Ref: 300001PM MO/BM

8<sup>th</sup> August 2018

**RE: IVANHOE ESTATE MASTERPLAN,  
STORMWATER AND DRAINAGE ASSESSMENT ADDENDUM**

# CURRENT DESIGN ENVELOPE PLAN

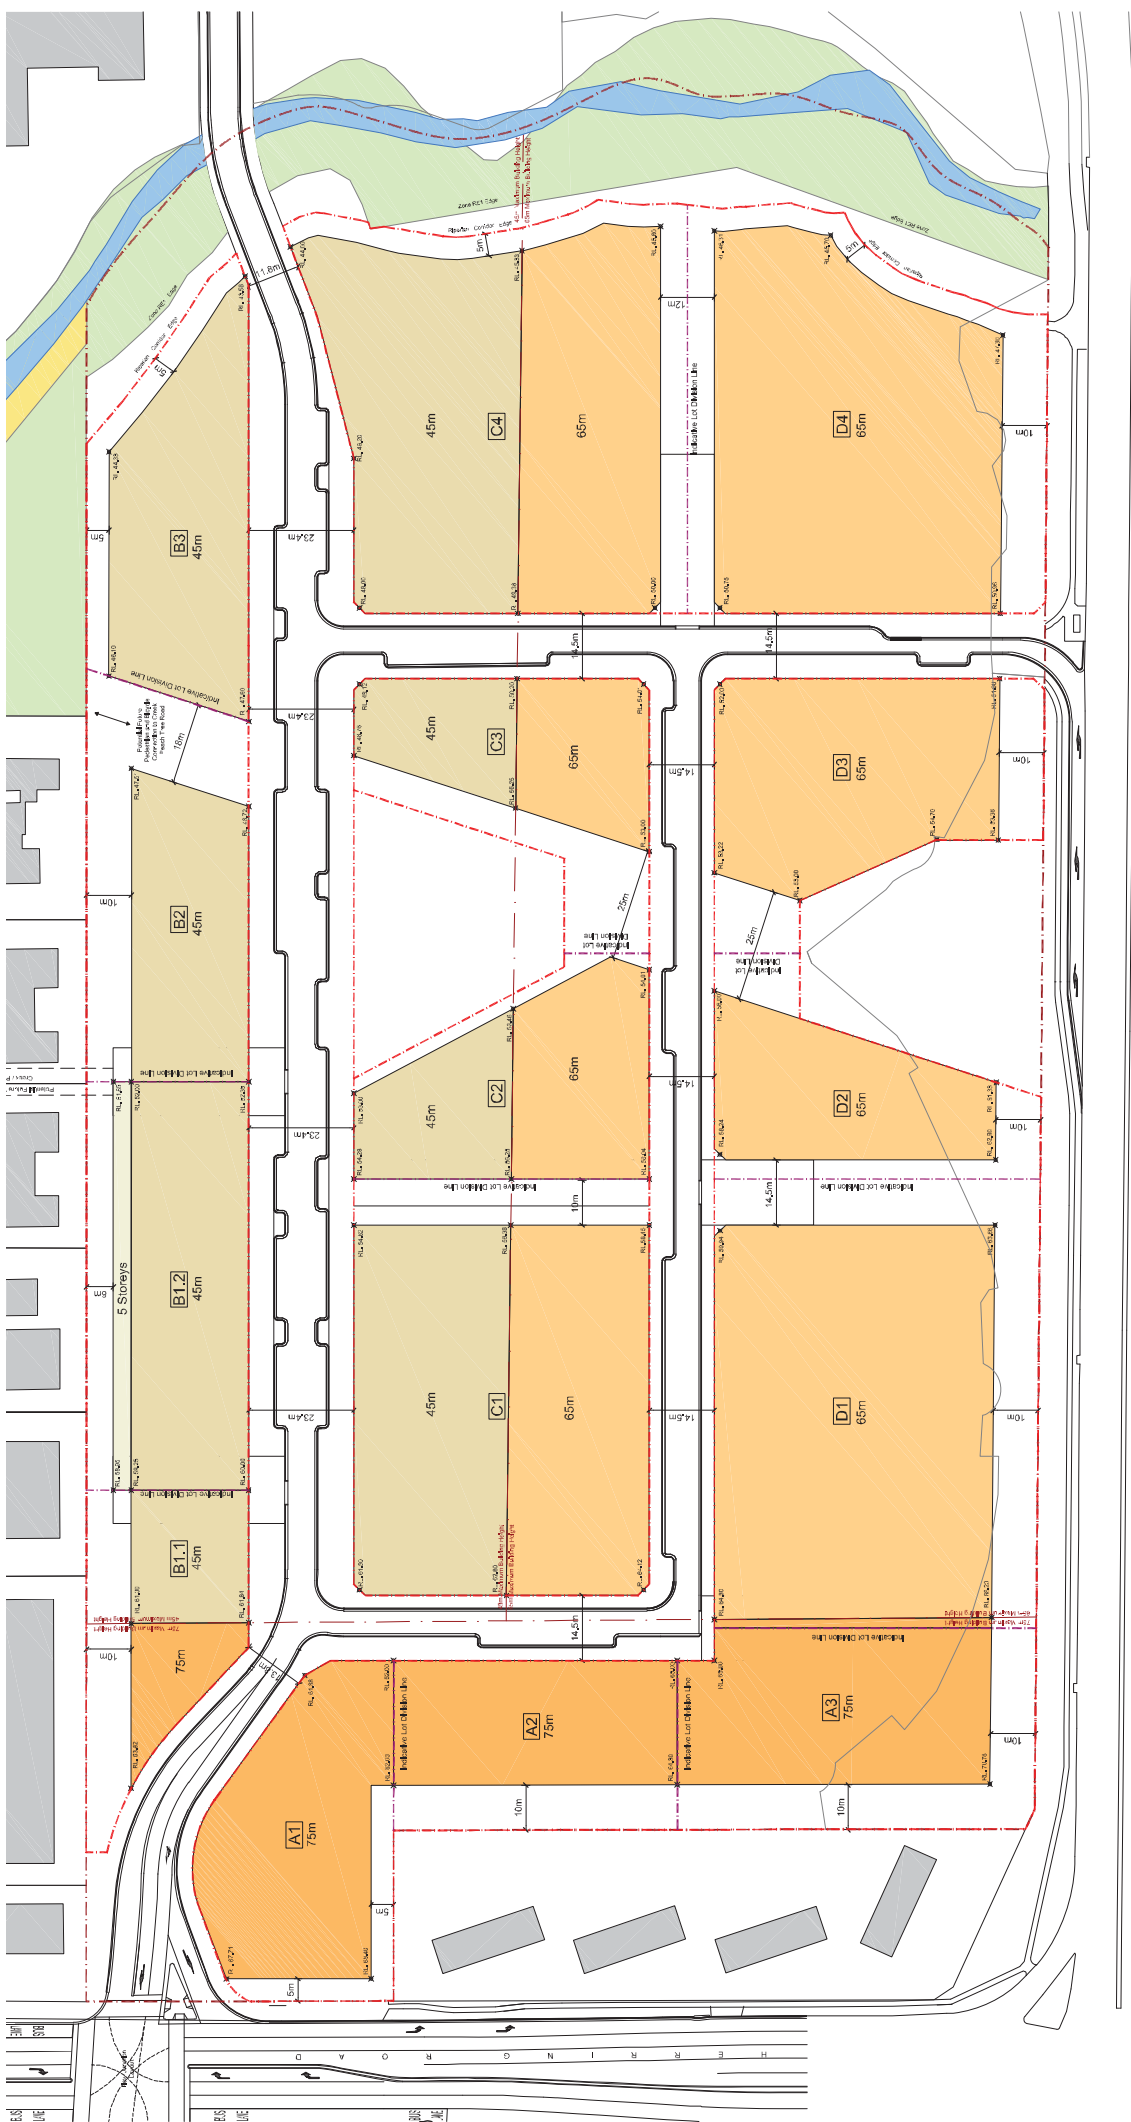
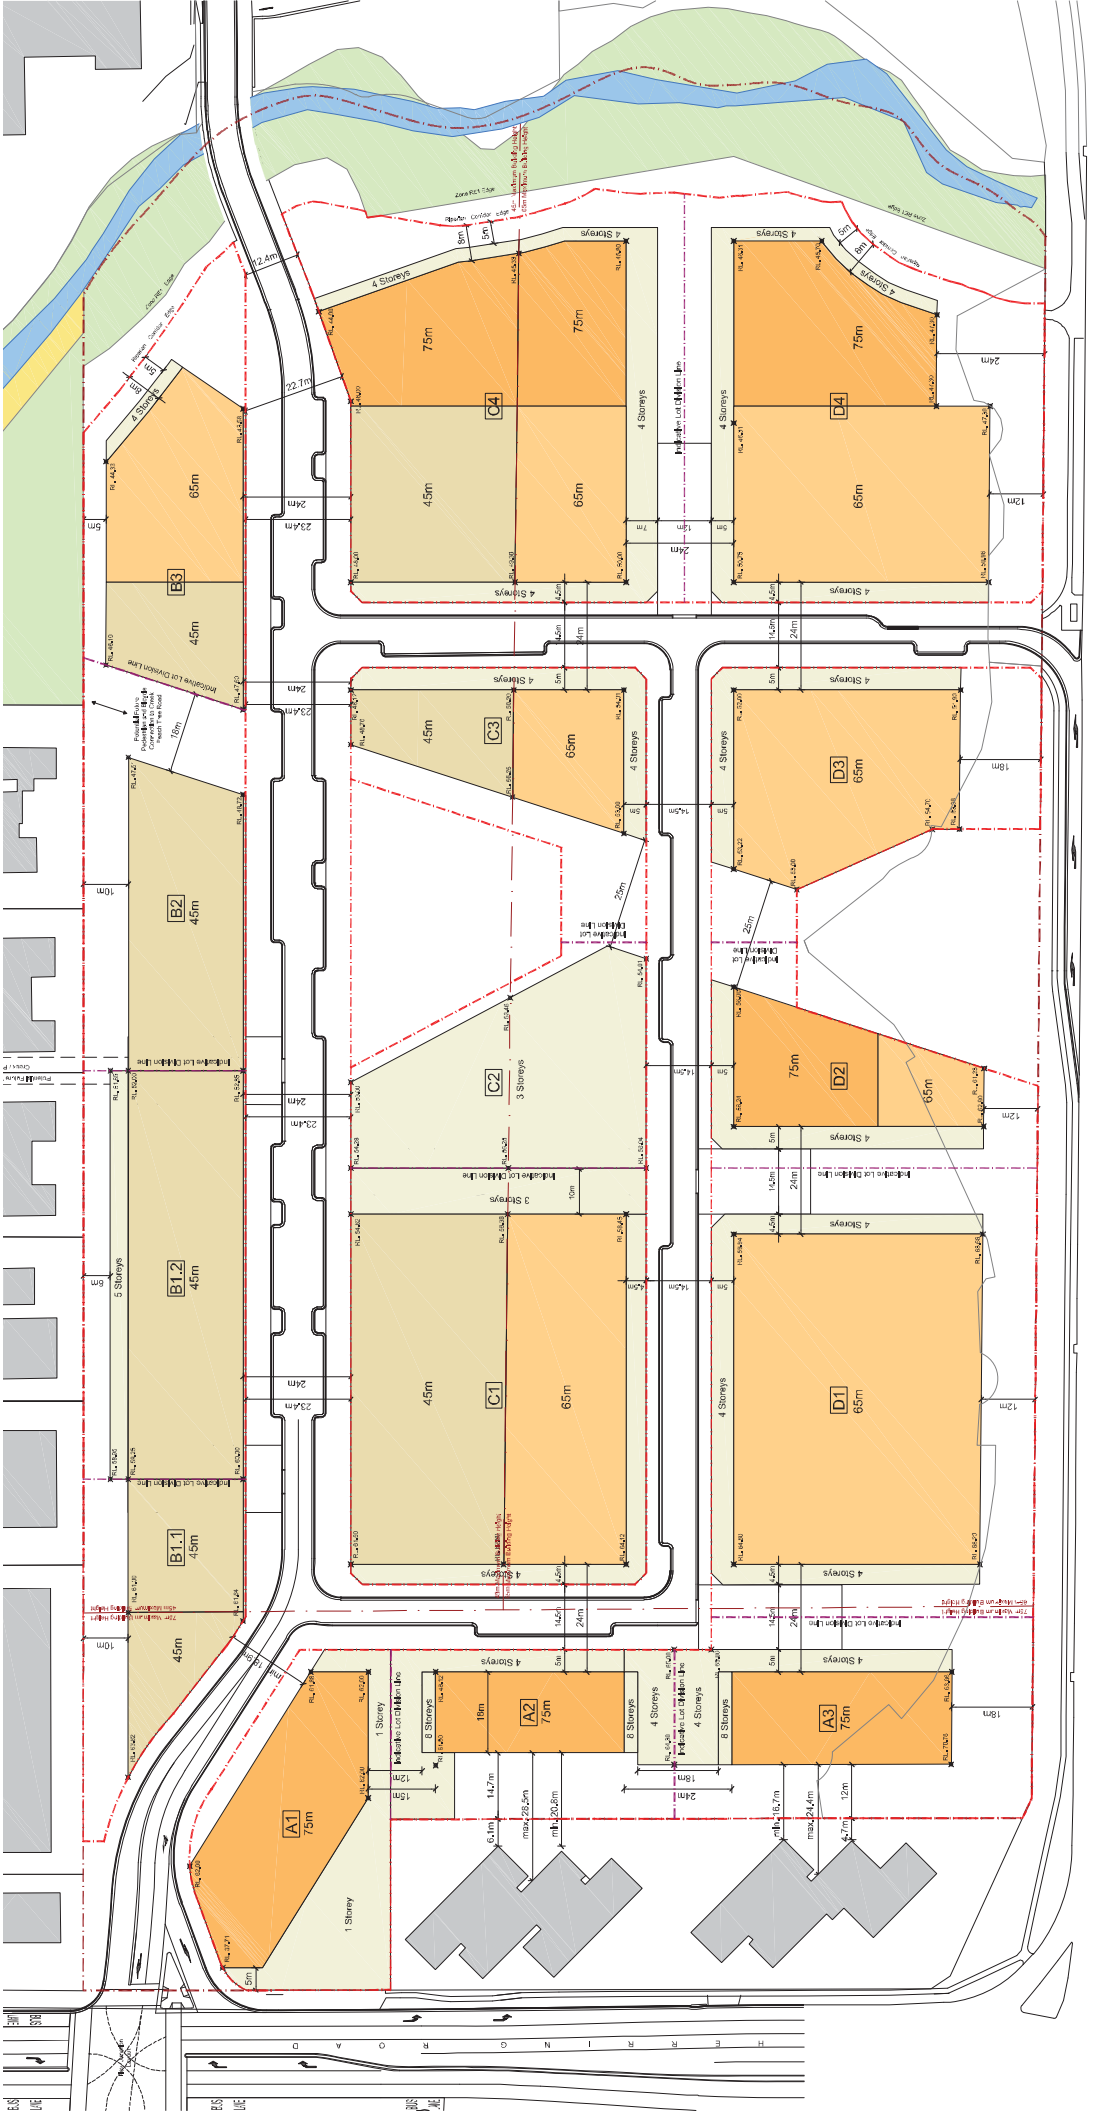
- Removal of building C2;
- Modification of building shapes throughout the masterplan.

The largest change to the masterplan was the complete removal of building C2 from the development. From a stormwater perspective, the removal of building C2 will likely mean a reduction in impervious area and therefore a reduction in the peak discharge leaving the lot containing it.

Throughout the masterplan, a number of building shapes have changed from those proposed in the original Stormwater and Drainage Assessment. As the building shapes were used to determine the roof catchment areas in the original assessment, any change in building shape will have an effect on the roof catchments.

Notwithstanding the above, it is noted that the roof areas proposed in the updated masterplan have generally reduced in area and will therefore result in lower peak discharges. It is also considered likely that, throughout the life of the project, building shapes will continue to be refined and roof areas will once again change. As these changes will be assessed with the individual development applications, it is considered that the original Stormwater and Drainage Assessment is still valid, despite the changes to the masterplan.

As the likely effect of removing C2 on the proposed stormwater system will be negligible, it is considered that the Stormwater and Drainage Assessment, submitted as part of the SSDA, is still valid.

As such, it is considered that the original Stormwater and Drainage Assessment is still valid despite the changes to the masterplan and therefore it does not need to be amended.
